Metropolitan Historic Zoning Commission
Sunnyside in Sevier Park
3000 Granny White Pike
Nashville, Tennessee 37204
Telephone: (615) 862-7970
Fax: (615) 862-7974

STAFF RECOMMENDATION
1205 Linden Avenue
July 17, 2013

Application: Demolition; New construction – infill
District: Belmont-Hillsboro Neighborhood Conservation Zoning Overlay
Council District: 18
Map and Parcel Number: 10513009400
Applicant: Nick Dryden, Architect
Project Lead: Sean Alexander, sean.alexander@nashville.gov

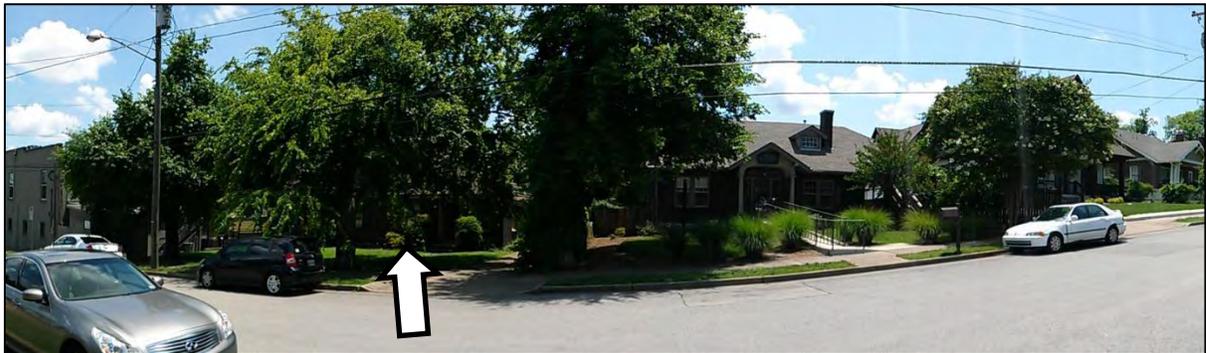
For this reason, staff finds that new construction at 1205 Linden should relate to that context and not the commercial buildings that face 12th Avenue South. Staff finds that the flat roof of the proposed infill is not compatible with the context and does not meet design guideline II.B.1.e.

The top of the parapet wall of the proposed new building would be twenty-five feet (25') above grade, which is compatible with the heights of nearby historic buildings. The front of the building would be sixty-one feet (61') wide, which is wider than most historic houses nearby but is appropriate given that the lot is seventy-six feet (76') wide. Although the overall height and width of the building may be appropriate, the form of the building is not compatible with the surrounding historic context.

The sixty-one foot (61') overall width of the building would be composed of three components: a thirty-six foot (36') wide two-story primary mass, a nine-foot (9') wide two story lateral "tower," and a sixteen foot (16') wide elevated "bridge" in the center with a breezeway/driveway below. This form is not like any contributing buildings in the Belmont-Hillsboro Neighborhood Conservation Zoning Overlay. This three-part form with a large open space in the center would also be incompatible with the dominant rhythm of the street established by whole structures with open space between buildings. Staff finds that height of the proposed building would meet guideline II.B.1.a., but that the scale and form would not meet guidelines II.B.1.b. and II.B.1.c.

The left and center bay of the primary component of the structure would have door and window patterns compatible with those of surrounding historic houses, however the elevated bridge and two-story tower would not. In addition to the large breezeway opening noted before, the “tower” bay on the right would have just one window opening spanning both stories. This type of window opening is occasionally seen on side elevations at the level of a stair landing, but is not typical of a front elevation. A large window in the upper-right corner of the primary two-story mass, cantilevered from the primary wall, is also atypical of contributing buildings. Overall, staff finds that the proportion and rhythm of openings of the proposed design does not meet guideline II.B.1.g.

Site Plan

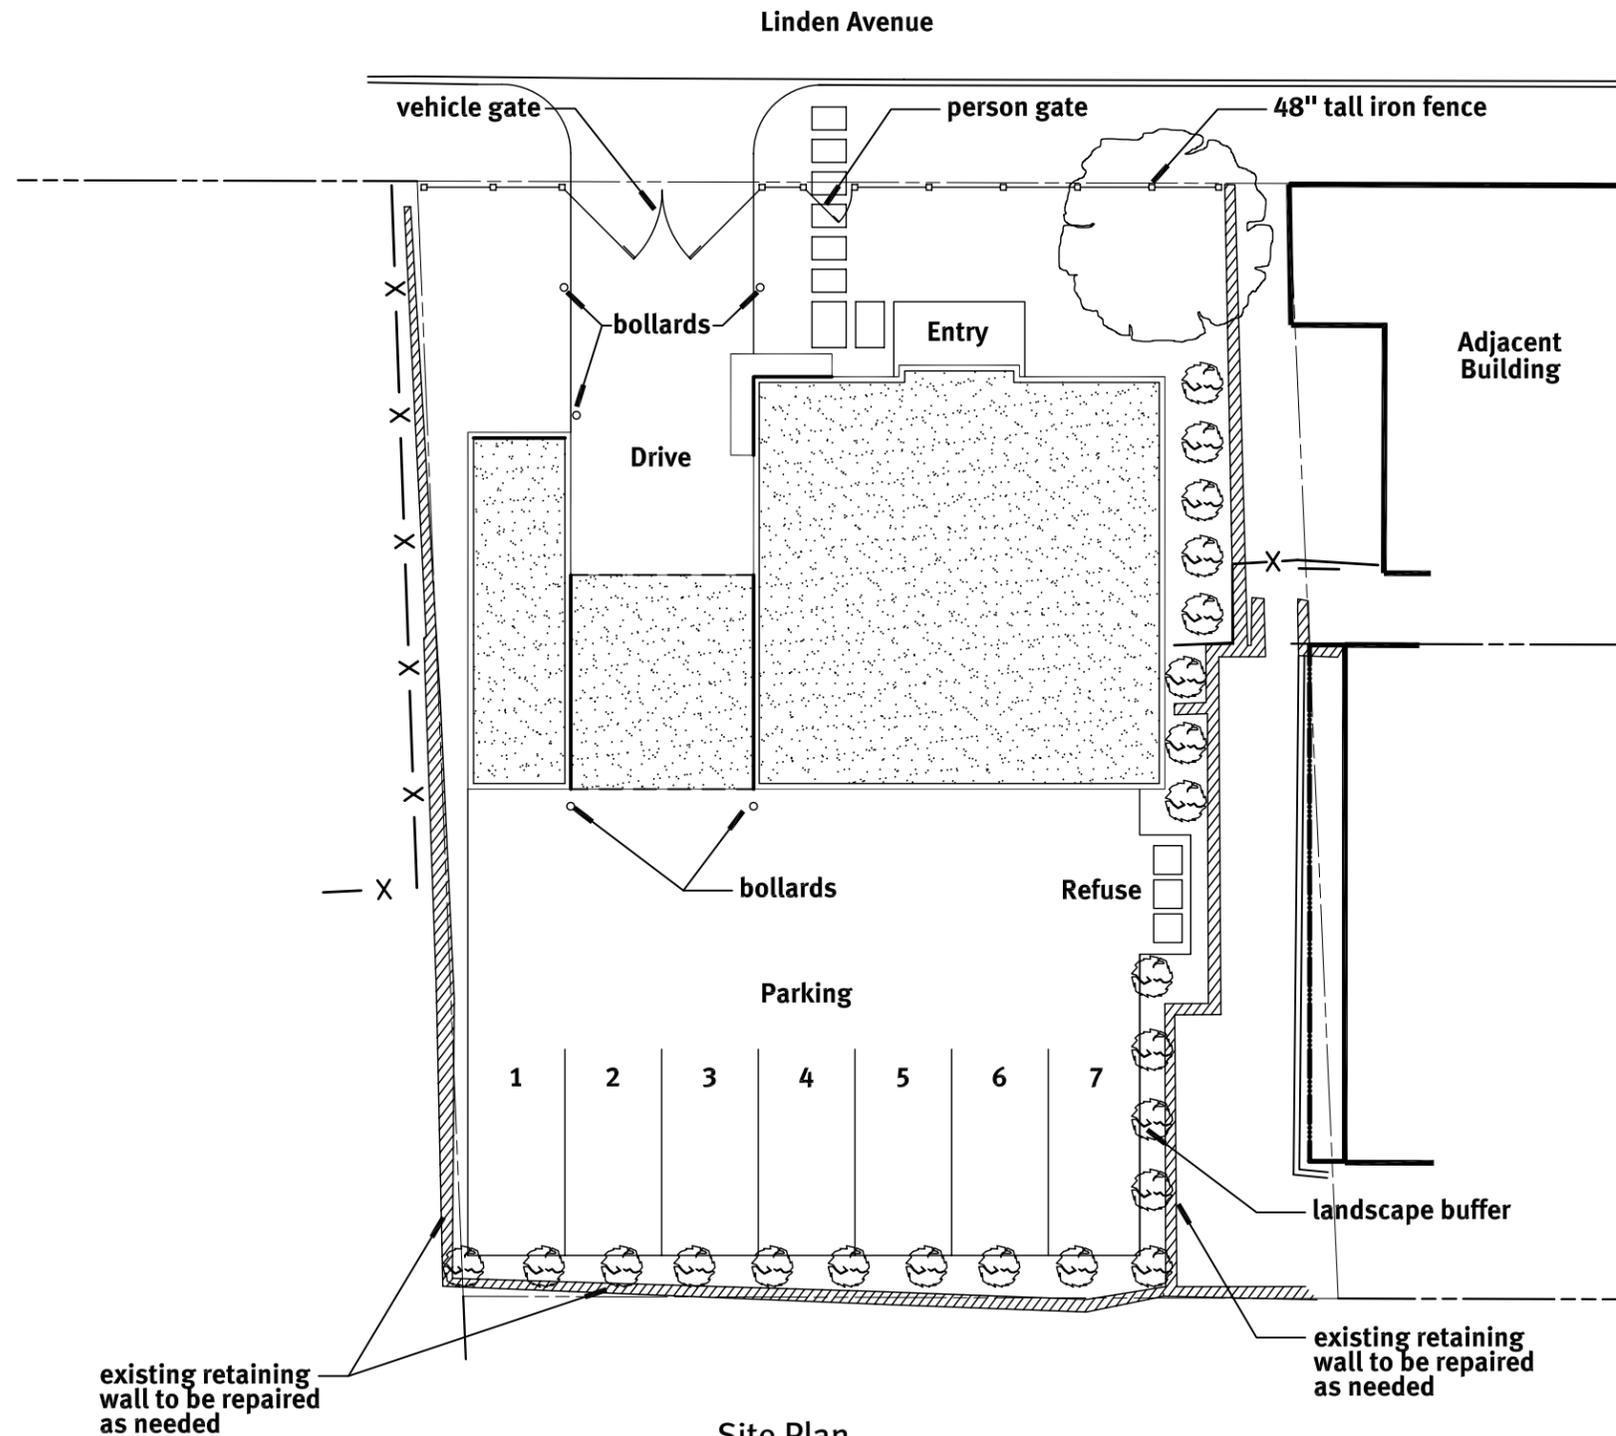
The building would be located with the left side sitting twelve feet (12') from the property line and the right side only four feet (4'). These distances would maintain the rhythm of spacing between buildings and meet the setback requirements of the base zoning. The front setback would be sixteen feet (16') from the sidewalk. The front setbacks of contributing buildings on the block are in the range of twenty-five to thirty-five feet (25' – 35'). The adjacent building at 1207 Linden Avenue is set thirty-five feet (35') from the sidewalk. Staff finds that the front setback of the proposed building would not meet guideline II.B.1.c.

Because the property does not have alley access, a driveway for the new building would be appropriate. However, the proposal would relocate the existing driveway from the side of the property to the center, shifting the focus of the lot from "personal" to "vehicular," in much the same way as a front-facing garage door would. A prominent front-facing vehicle entrance is not compatible with the historic context and does not meet guideline II.B.1 and II.B.1.g.

Side Elevation
 1/8" = 1'-0"

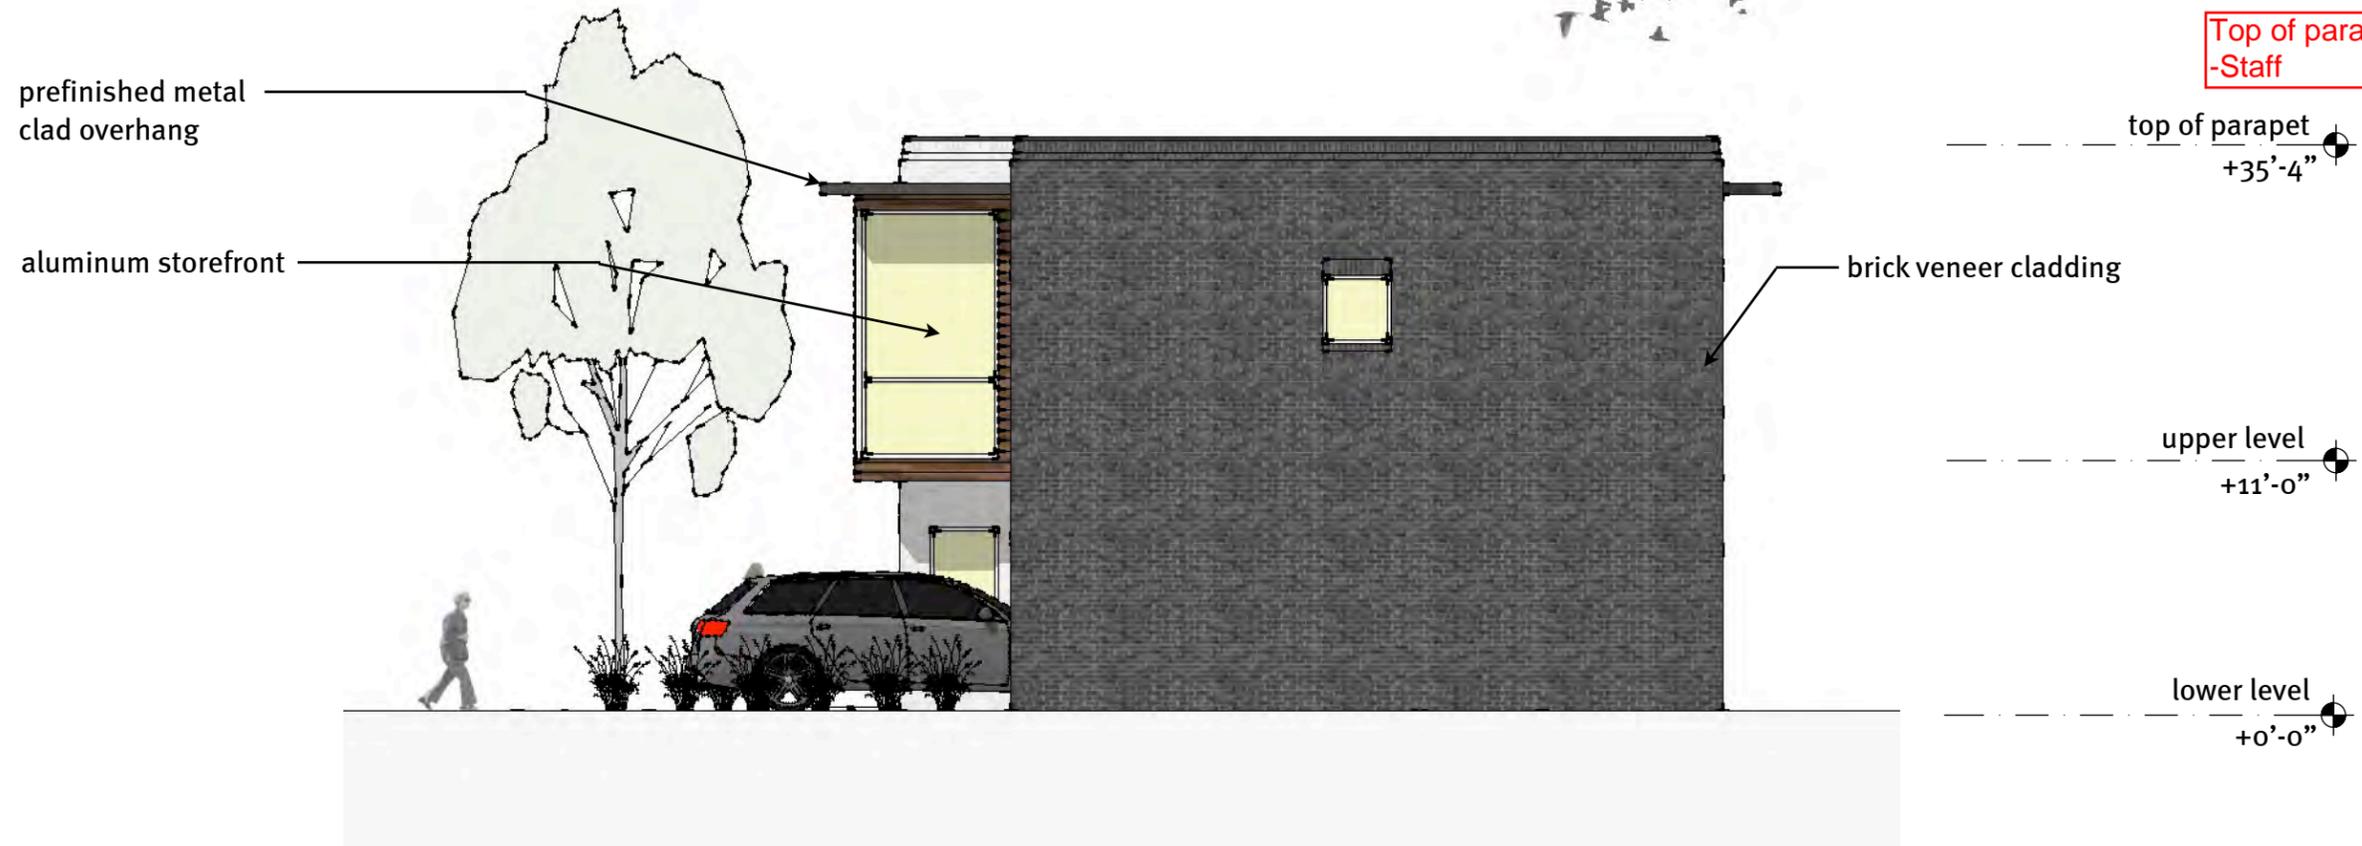
Top of parapet is 25' a.f.f. -Staff
